**PZ&B Staff Combination Memorandum: Town Council and Landmarks Preservation Commission**

**SUBJECT:** ZON-24-0019 (COA-24-0005) 1 S COUNTY RD—THE BREAKERS

**ZON-24-0019 (COA-24-0005) 1 S COUNTY RD (COMBO) SITE PLAN REVIEW– THE BREAKERS.** The applicant, Breakers Palm Beach Inc., has filed an application requesting Town Council review and approval for Site Plan Review for site changes including the modifications to the main entrance drive to the hotel and the porte-cochere arrival area. The Landmarks Preservation Commission shall perform design review of the application.

*Proposed drive entrance and main drive off S County Road*

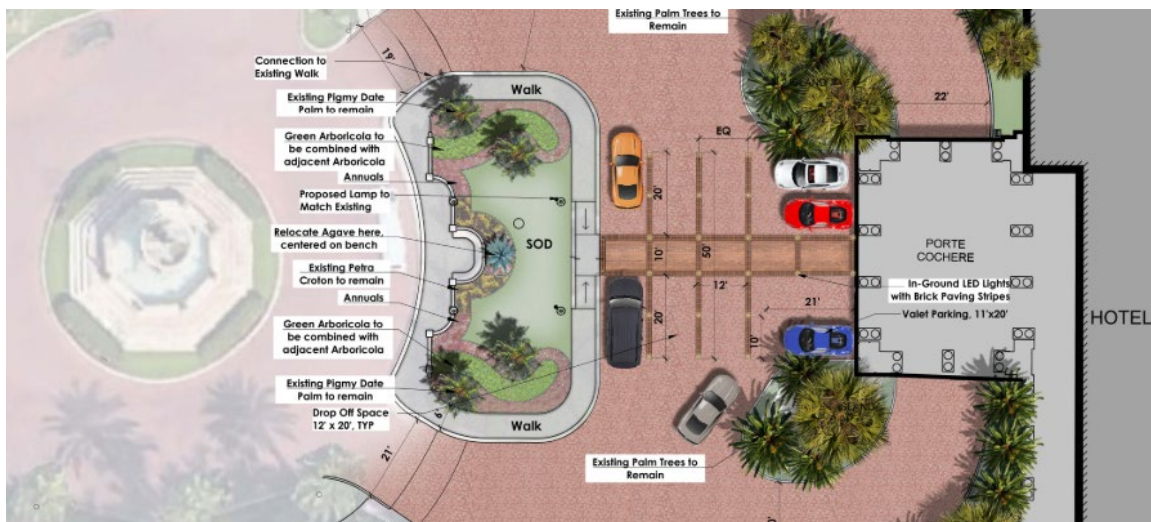
- Center inner egress lane on main entrance
- Expand Drive aisles to 12' wide lanes and introduce 1' wide mountable curbs with lighting.
- White brick double band to replace mountable curb until the point in which the width of road changes.
- Sidewalk to be relocated south & north of drive new drive aisles in front of palm trees.
- Sidewalks to be adjusted from 6.8' to 5.7' to accommodate existing palms onsite.
- Other landscape changes.

*Proposed front drop off area*

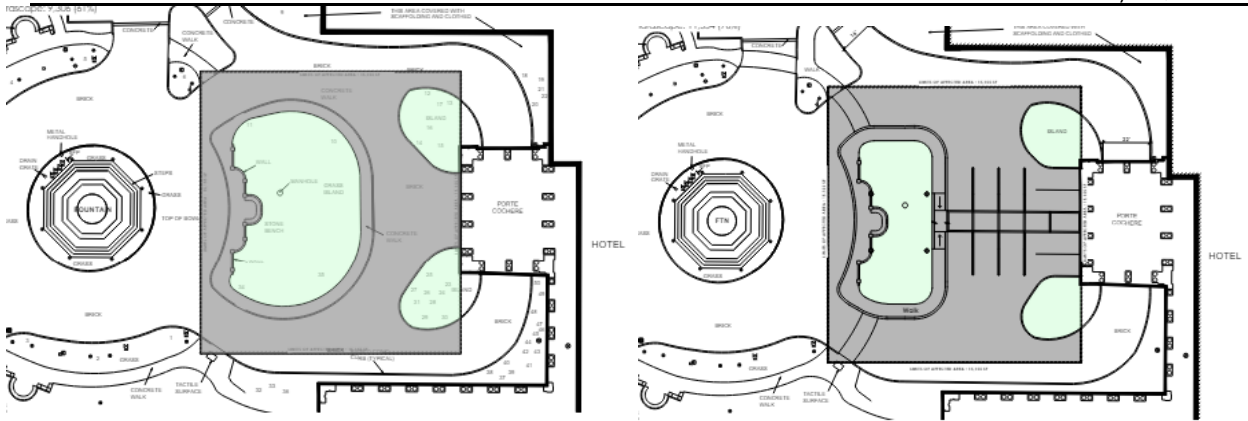
- Internal landscape island to be modified to improve traffic flow.
- Eastern curb of internal landscape island to be relocated west 23'.
- Sidewalk of internal landscape island to be relocated west 23'.
- Modify remainder of existing curb to tie into new curb line.
- Addition of two lamps to match existing on site.
- In ground LED lighting.

The hotel has made tremendous improvements to this property over the years including the removal of a significant amount of asphalt in the driveway and approach. However, staff has expressed concern about additional lanes and cars obscuring the columns of the Porte Cochere and the loss of green space. LPC will focus on the compatibility for the proposed vertical lanterns and the LED strips imbedded in the paving.
